**CITY OF ESSEX JUNCTION
DEVELOPMENT REVIEW BOARD
PUBLIC HEARING AGENDA**

**CITY OF ESSEX JUNCTION
DEVELOPMENT REVIEW BOARD
MINUTES OF MEETING
JULY 17, 2025
DRAFT**

To: Development Review Board
From: Michael Giguere, City Planner
Date: August 21st, 2025
Subject: Design review for the construction of a new single-family home at 40 Maple Street by Ron Bushey, owner.
File: SP# 6.2025

To: Development Review Board
From: Michael Giguere, City Planner
Date: August 21st, 2025
Subject: Conditional use review for the addition of an exterior propane gas pump, design review, and site plan review for Tractor Supply Company at 70 Pearl Street in the Transit-Oriented Development (TOD) district by Cathy West, Parkway C&A, LP and Brandon Kubik c/o Pulley Studios, Inc. on behalf of Shawn Handy c/o Handy's Hotel & Rentals LLC, owner.
File: SP# 7.2025

40 MAPLE ST

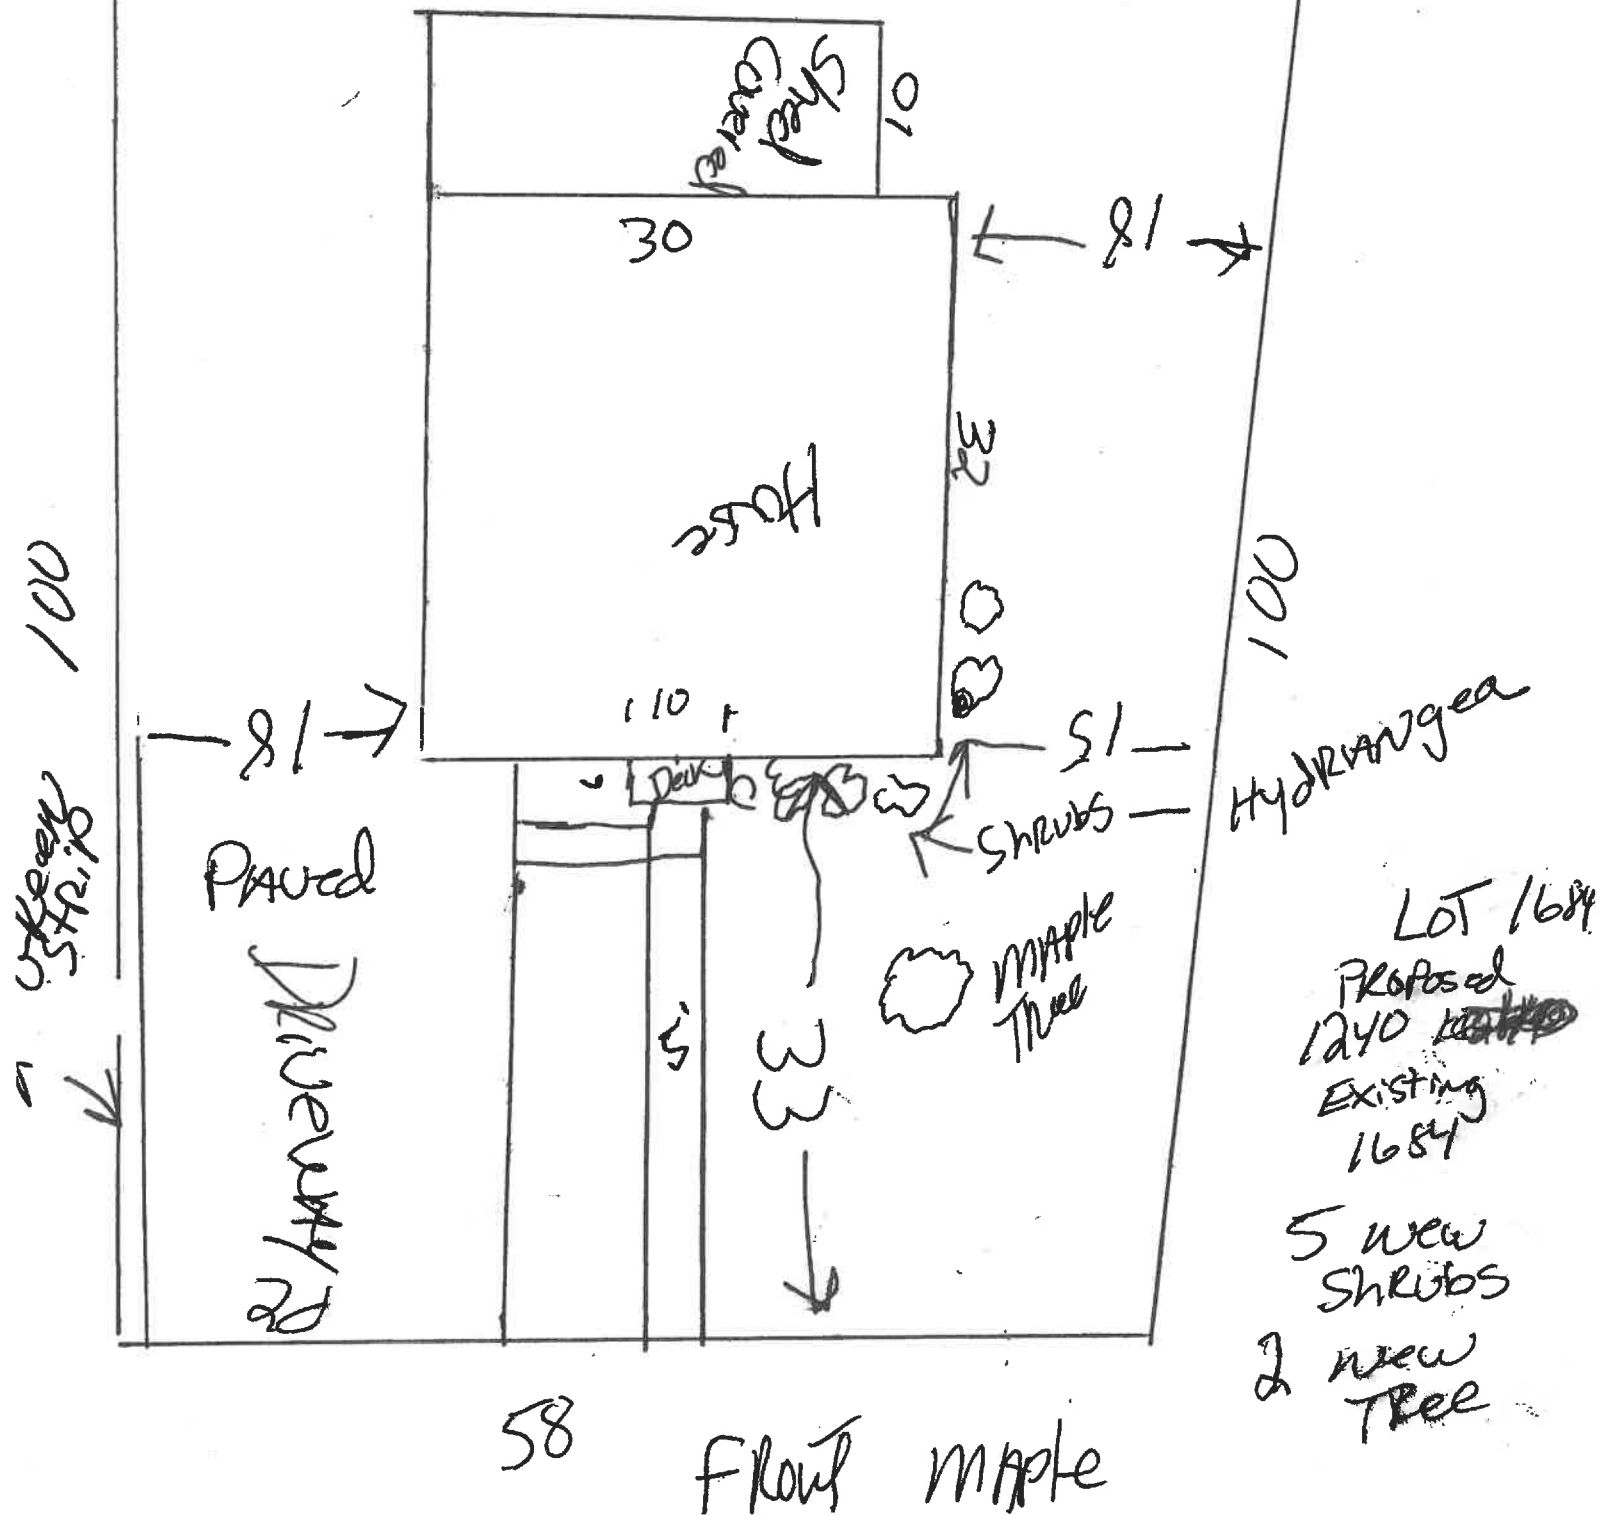
Based on feedback from the DRB in July 2025, the applicant has proposed setting the home back further from the street (33') to provide room for a maple shade tree along Maple Street in addition to five (5) new shrubs in front of the home and a maple shade tree along Kings Court in the backyard of the home. They have also indicated the location of existing landscaping materials on their site plan.

3/16 scale

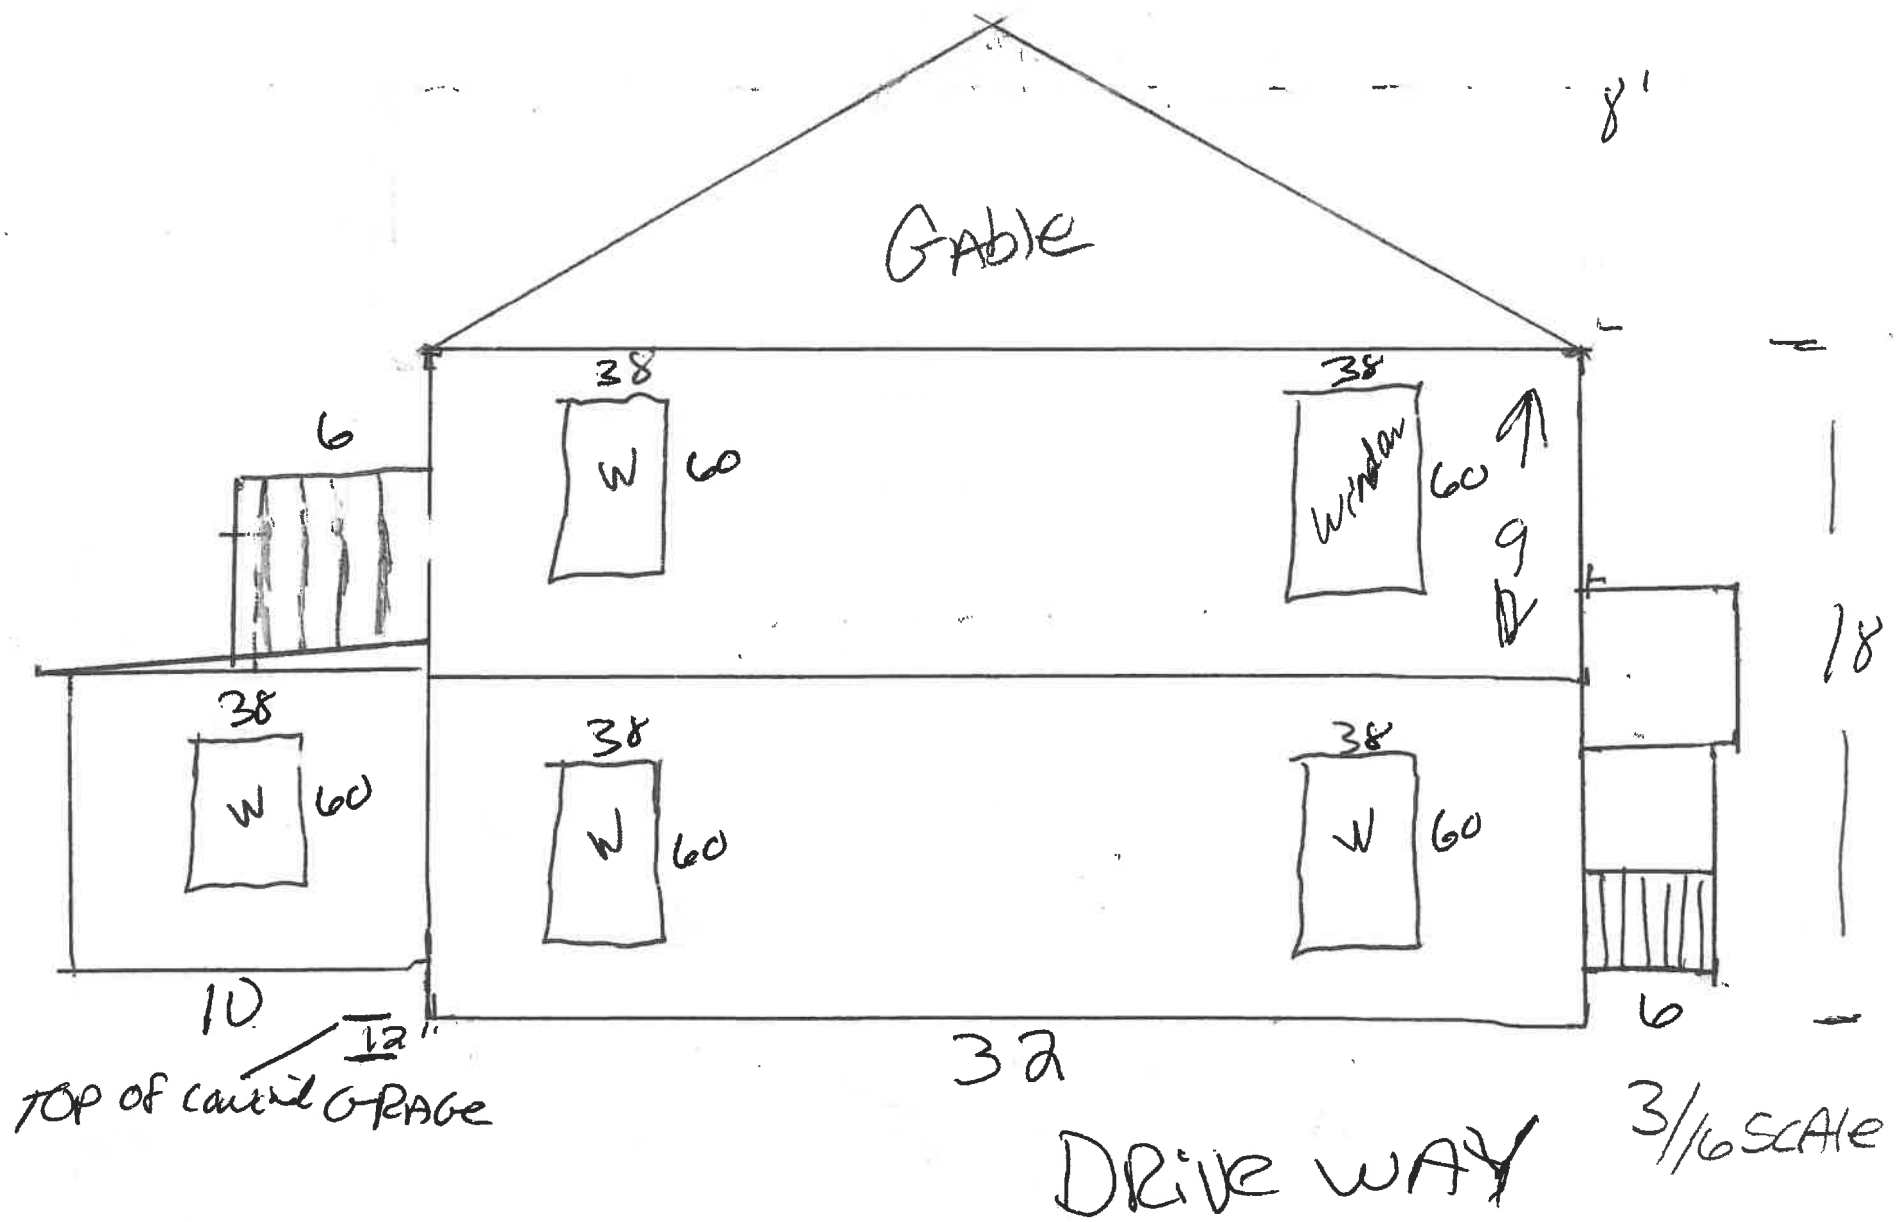
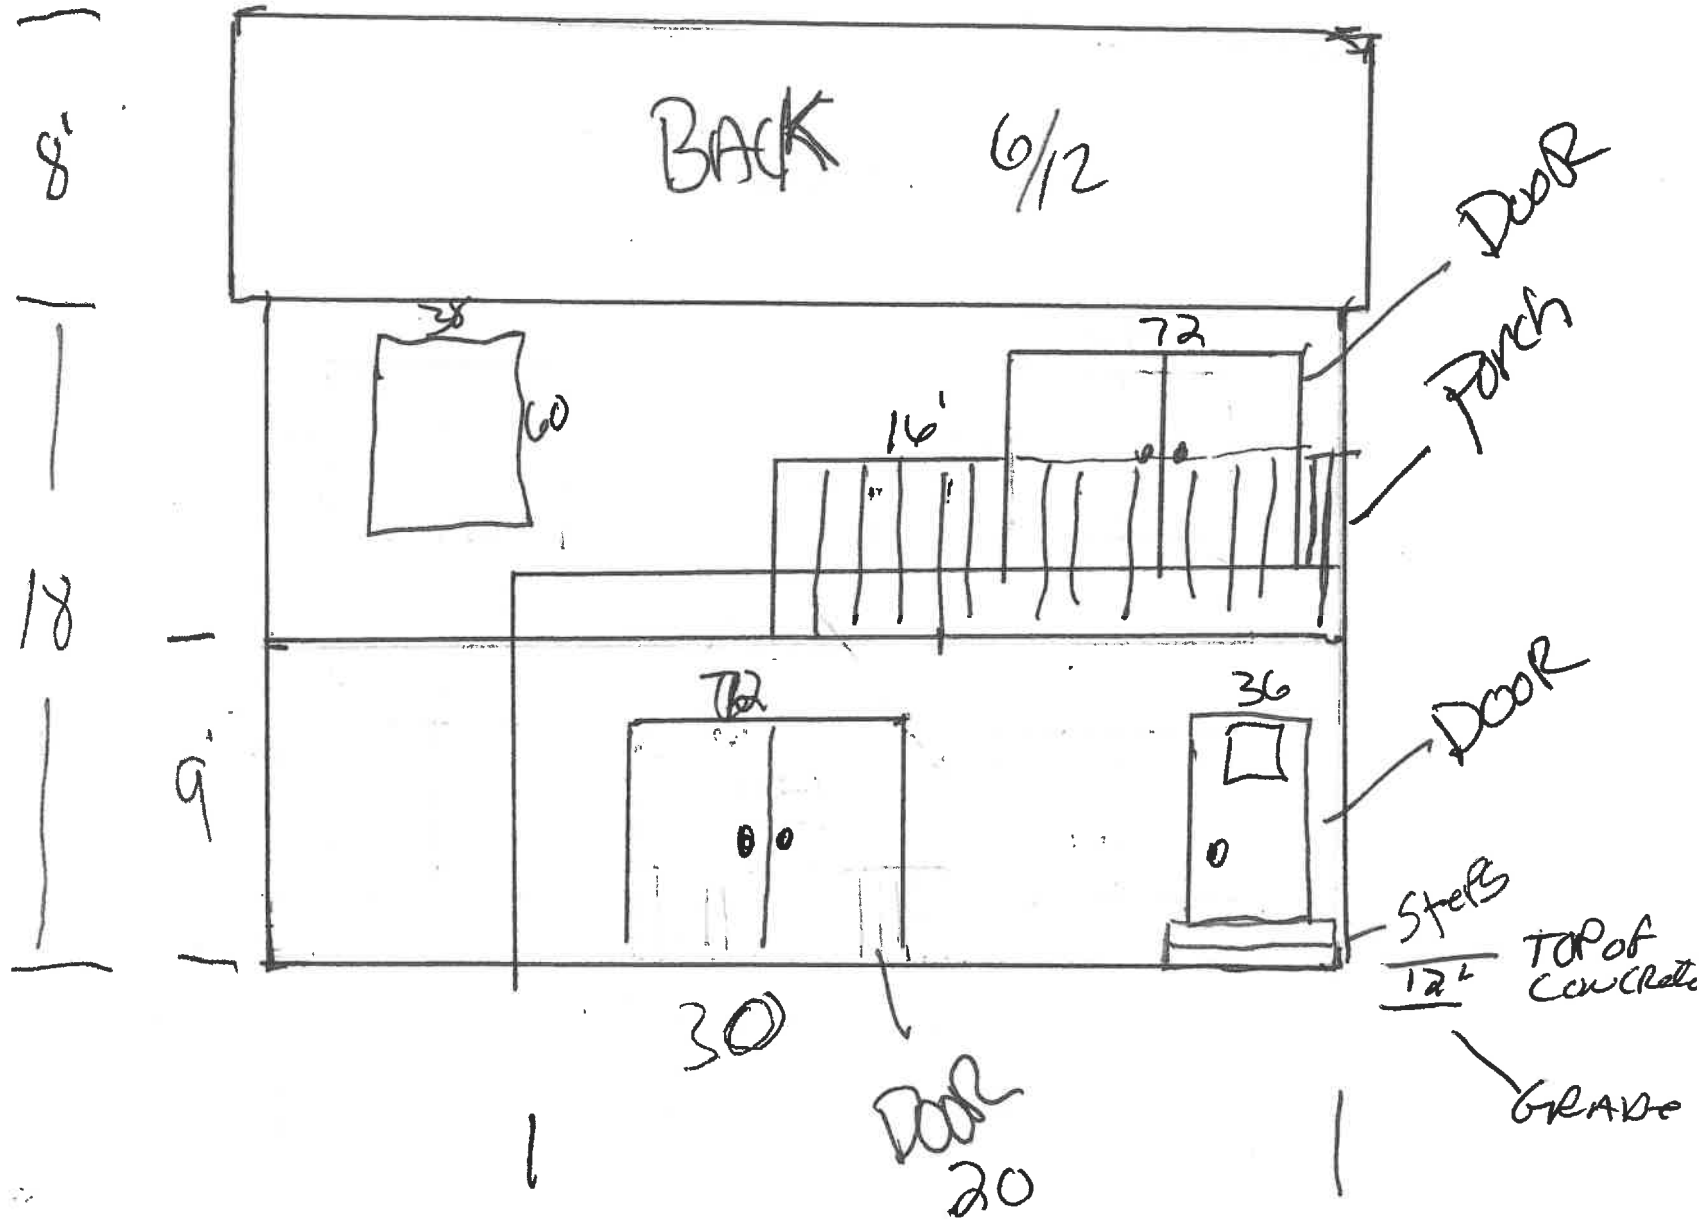
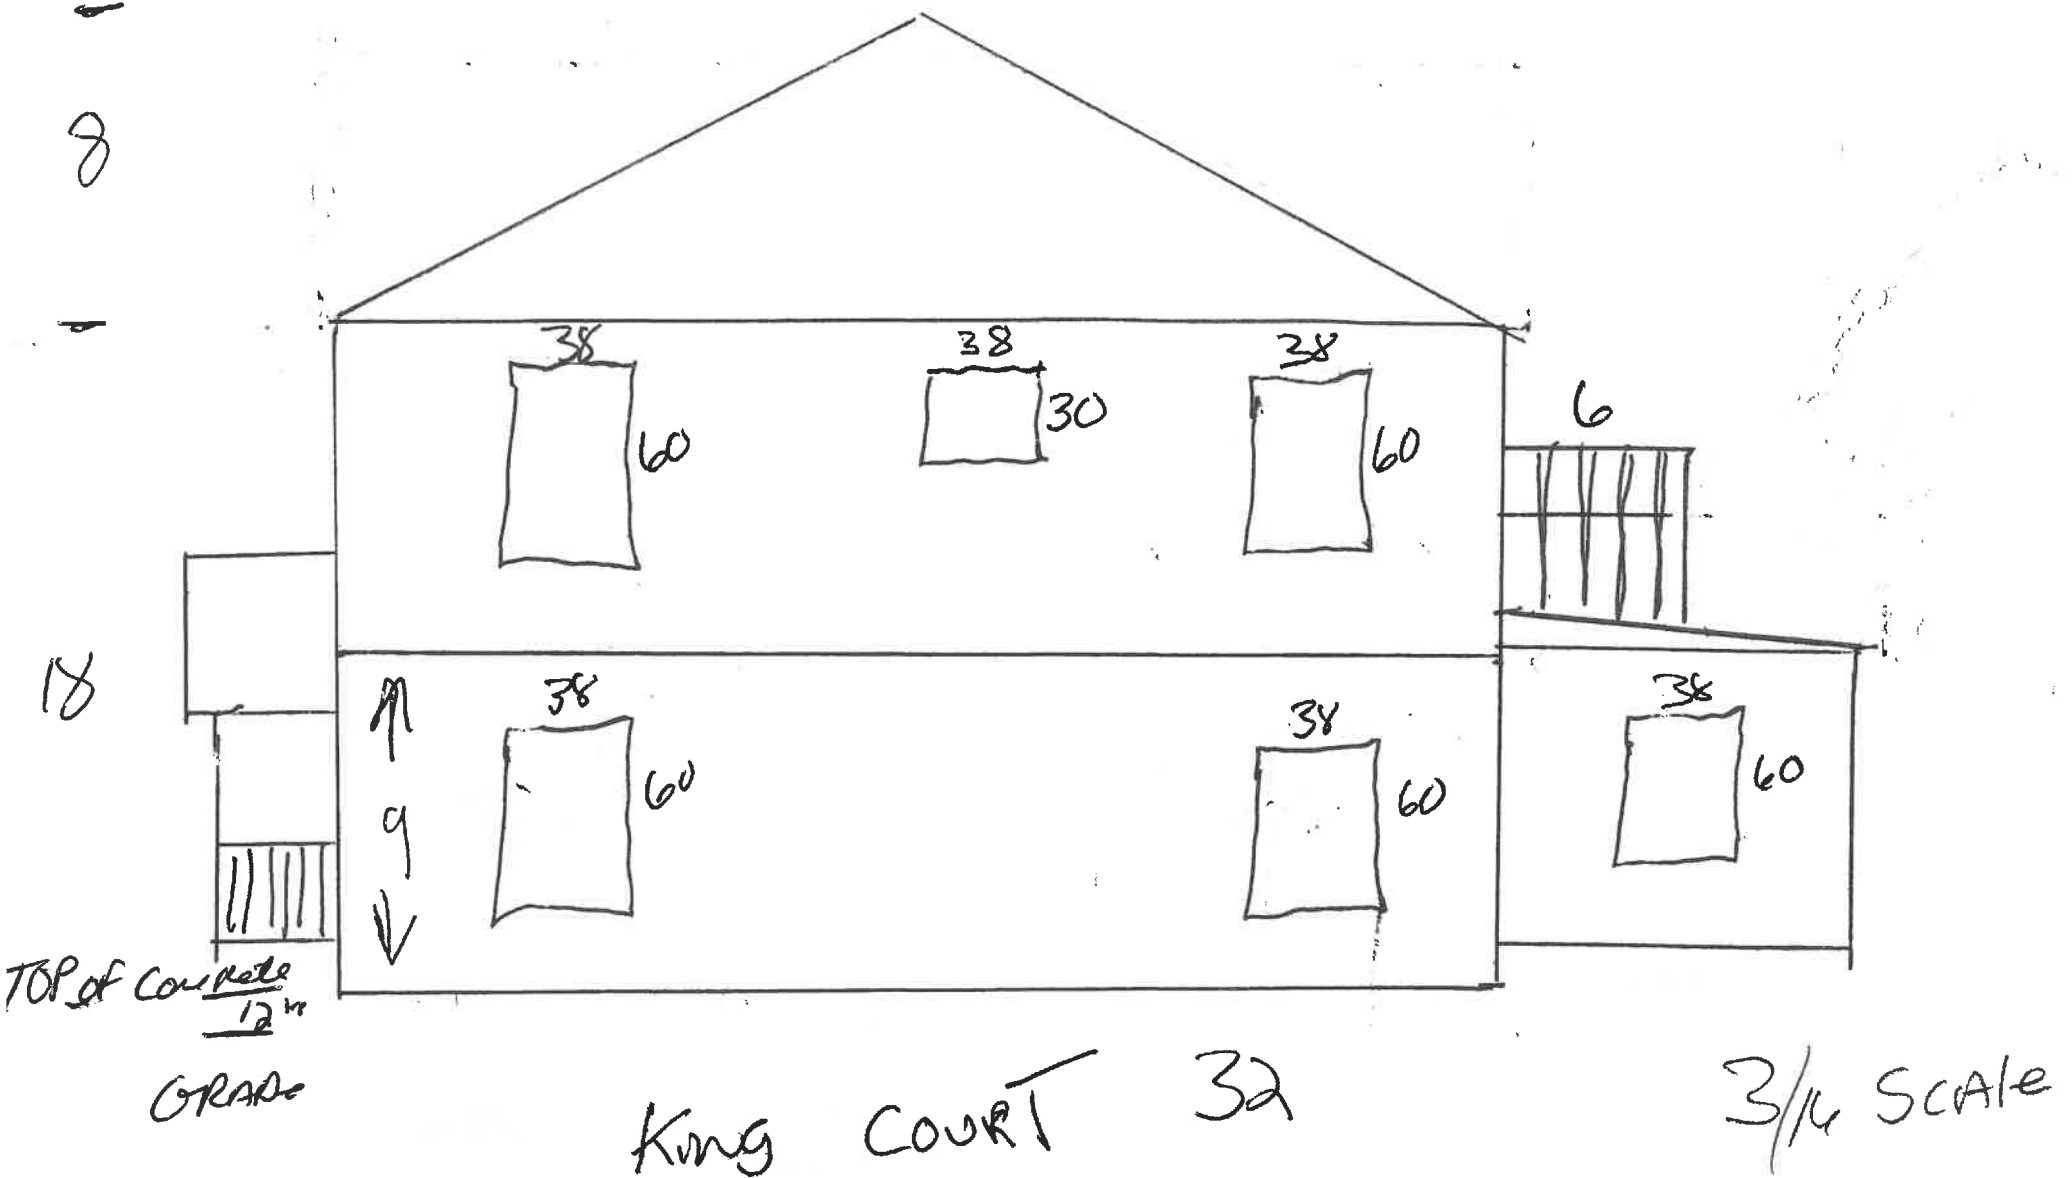
While staff find that the updated elevations generally harmonize with the intention of Section 620 and include two required site features (direct pedestrian access and shade trees), some details are not drawn precisely to scale, with most discrepancies falling in the range of 1 - 16% error. An example from the east elevation is shown below in Figure 1, demonstrating that the drawn porch dimensions do not match the scale provided:

Figure 1: Excerpt from east elevations of the proposed home demonstrating scale discrepancy.

The drawing may also lack some details on features such as roof eaves (West and East Elevations), although it is possible that the applicant does not intend to include eaves.
